REPORT / RECOMMENDATION

Subject: Sketch Plan – 3655 Hazelton Road for Think Bank.

A. Sketch Plan – 3655 Hazelton Road, Edina, MN

Re: Sketch Plan Review – 3655 Hazelton Road

SITE PLAN - OPTION 'D' REVISED

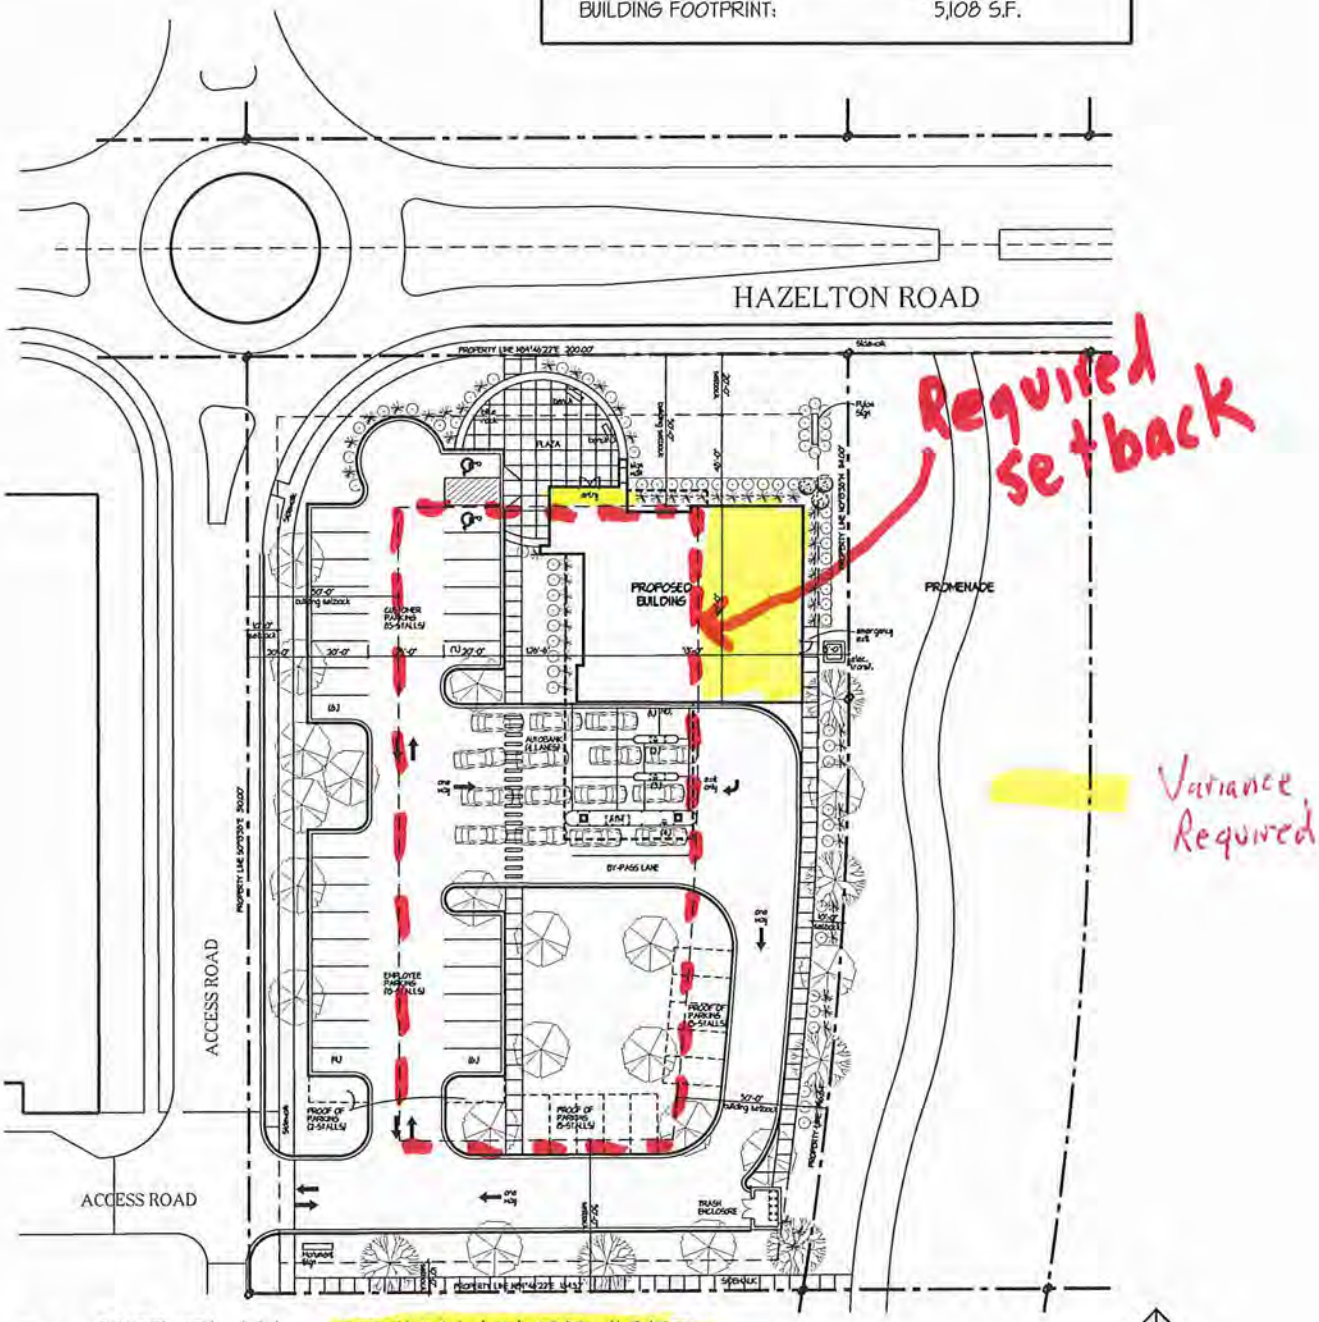
The applicant is presenting four alternatives for the City Council to consider and provide feedback prior to an official application. Option B would not require any variances as proposed. Options A, C and D would require building setback variances. Option D is the direct result of the Planning Commission discussion of Options A-C.

Planning Commission Consideration: On September 25, 2013, the Planning Commission considered the sketch plan proposal. (See attached minutes.) Planning Commission recommendations included: moving the building closer to the Promenade and Hazelton Road; parking on the west side of the building; removal of some parking spaces, added landscaping; and connections to the Promenade.

1 A1.1 SITE PLAN - OPTION "A"
1"=40'-0"

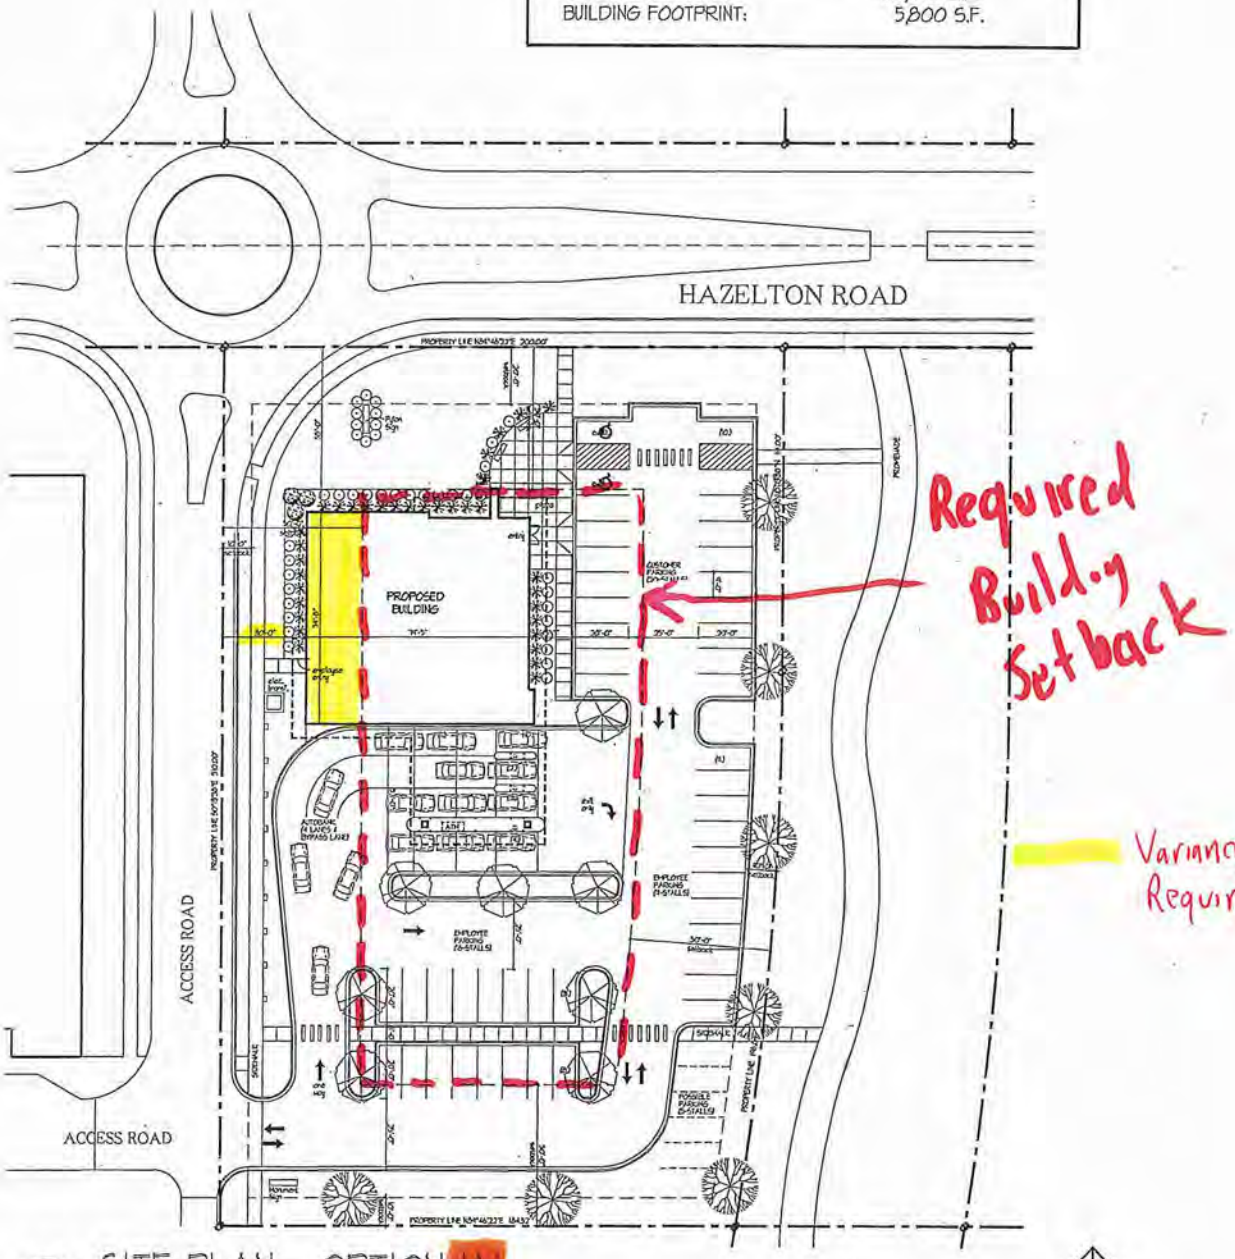
Commissioner Grabiel asked Mr. Pflipsen for clarification on the reason buildings A & C are similarly located. Mr. Pflipsen indicated they brainstormed building placement and located the buildings on options A & C closer to Hazelton and the access road between the subject site and Byerly's per discussions with City staff. Continuing, Pflipsen stated these two scenarios provides the Commission and Council with building placement options; either (A&C) buildings located farther from the Promenade and closer to the street (Hazelton) or option B, a building more centrally located. Continuing, Pflipsen said one component that drives building placement is the drive through for the bank; a counter clockwise movement is required.

Mr. Pflipsen In response to the discussion explained that the rationale for offering options A & C was at the suggestion of City Staff, reiterating B works for them. Pflipsen explained that staff shared with them the importance of the Promenade and pedestrian flow, etc.

1 A1.1 SITE PLAN - OPTION 'B'
1"=40'-0"

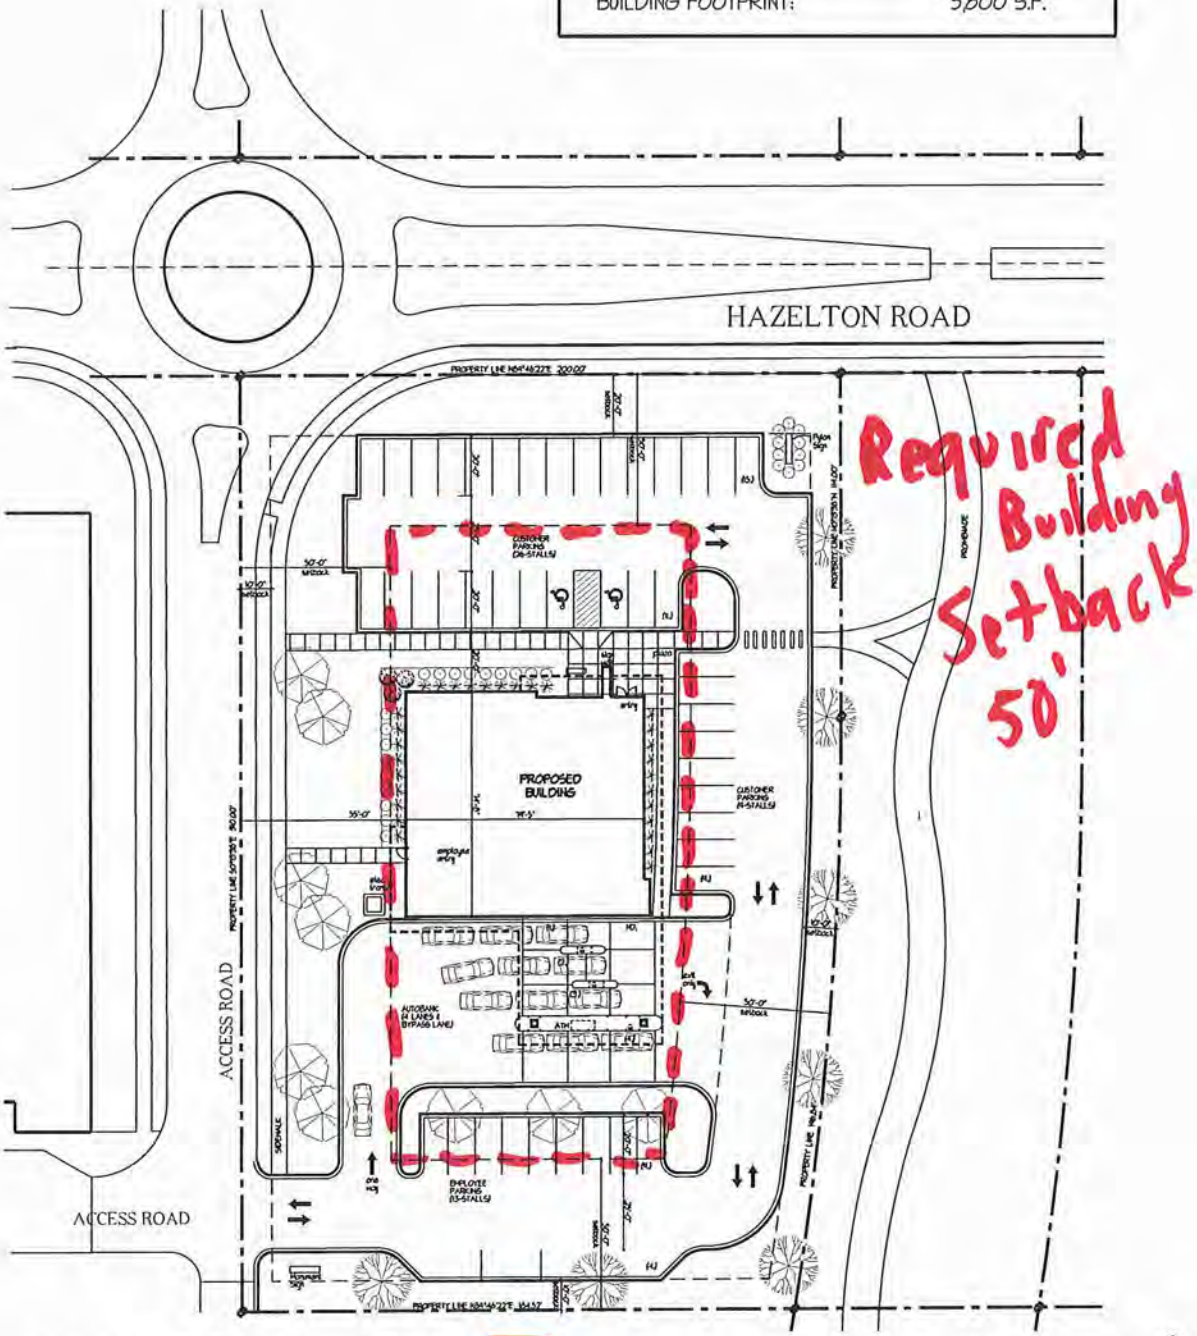
Commissioner Platteter questioned the reason the Commission is reviewing this as a Sketch Plan since what's submitted as option B meets ordinance requirements. Planner Teague responded that the applicant indicated they wanted feedback from the Commission on differing options with the understanding that in this area the City is looking for specific things.

Commissioner Carr stated she is satisfied with the layout presented in Option B with revisions, adding in her opinion this doesn't have to be a disappointment if redeveloped with the suggestions from staff, the Commission and further suggestions from the City Council. Carr said if some parking spaces were eliminated and the site was well screened from the Promenade to include a connection to the Promenade this use may work well. Carr said she agrees with the suggestion of lining up the proposed building with the Byerly's building to establish continuity. Concluding, Carr said she is a member of the Living Streets Committee and asked the applicant to also consider adding bike racks.

Commissioner Forrest stated shifting the building to the northeast could work along with increased landscaping. Continuing, Forrest said with more thought Option B could be rearranged and depicted more in context with the surrounding area, adding she believes it could also work. Forrest said this

1 / A1.1 SITE PLAN - OPTION 'C'
1"=40'-0"

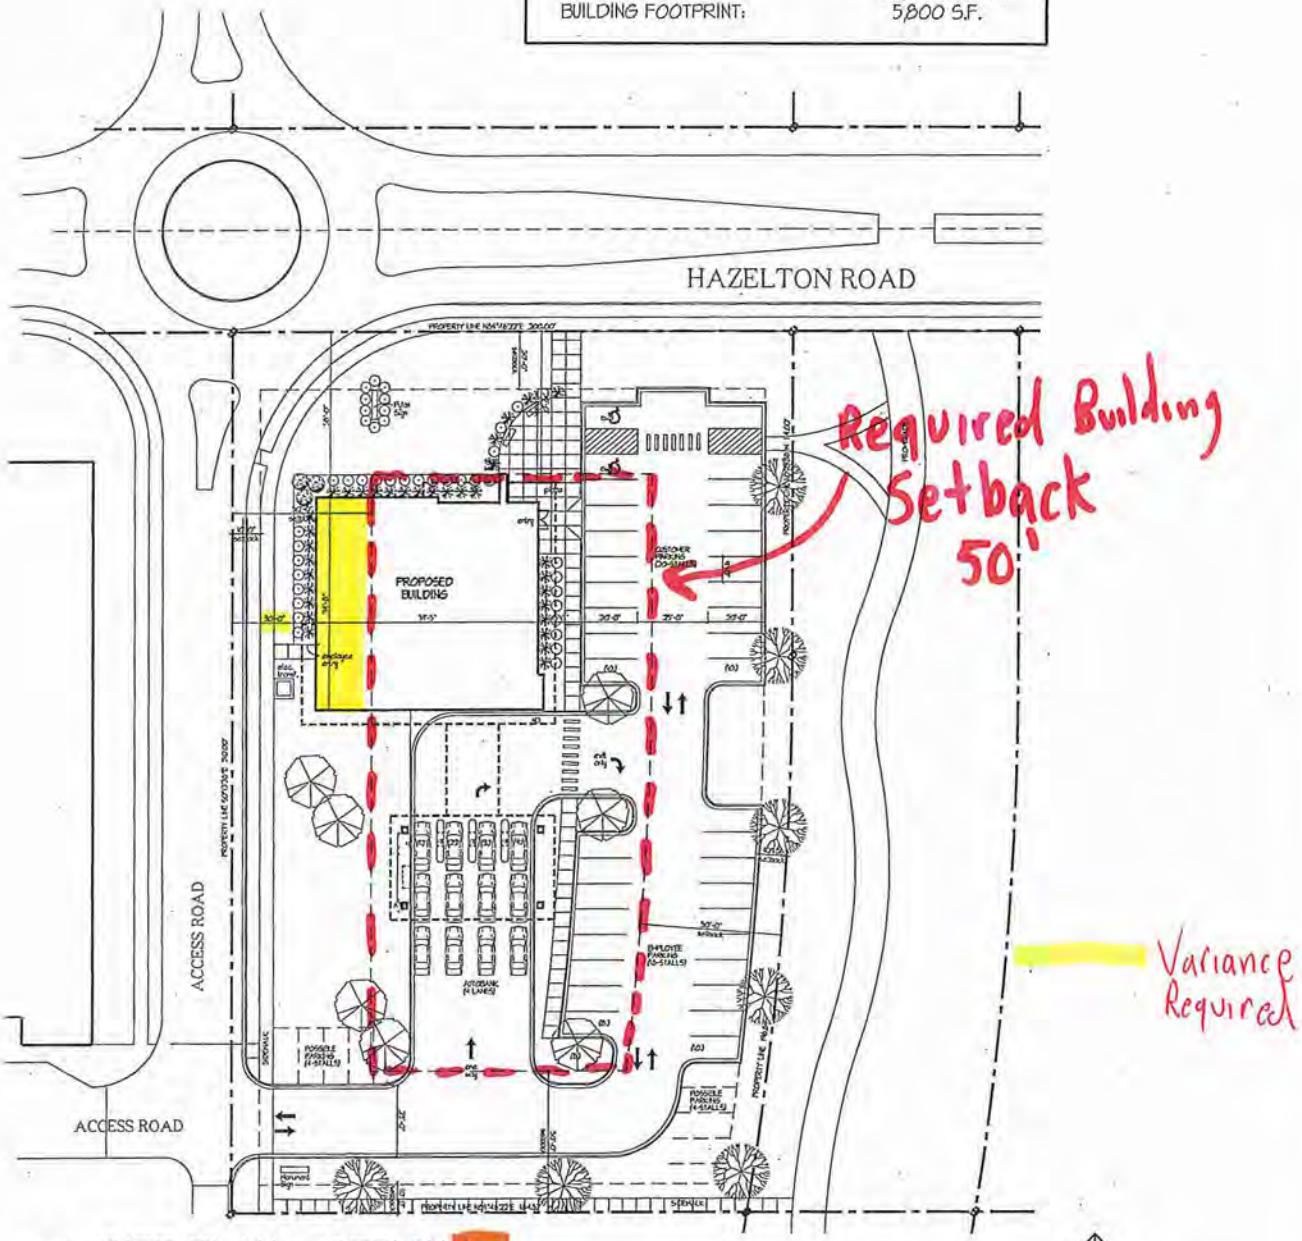
Commissioner Schroeder said in his opinion in viewing Option C he would prefer to see the parking oriented west and the building positioned closer to the street and Promenade to the east. He pointed out if built as depicted the building would be hidden by the Byerly's building (from Hazelton), reiterating moving it north and east would allow the building to be seen. Schroeder also noted that this reorientation allows left and right turns. Schroeder said he agrees with previous Commissioner comments that the "space" nearest the Promenade shouldn't be for parking. Schroeder also said he finds the building interesting and to the proper scale. Concluding, Schroeder said he supports less parking and more landscaping. Mr. Pflipsen stated Option C is the least preferred because it creates a "head on" traffic flow which reduces parking spaces closer to the building and creates difficulty for night deposits. Continuing, Pflipsen said moving the building up and farther east on the site would also eliminate more parking stalls. Concluding, Pflipsen said it can be done; reiterating it's not a banks preference.

Commissioner Platteter stated he agrees with comments from Commissioner Schroeder, adding some variation of Option C may better suit the site and area. Platteter also observed if the building is oriented closer to Hazelton the building would have more exposure, as previously mentioned by Commissioner
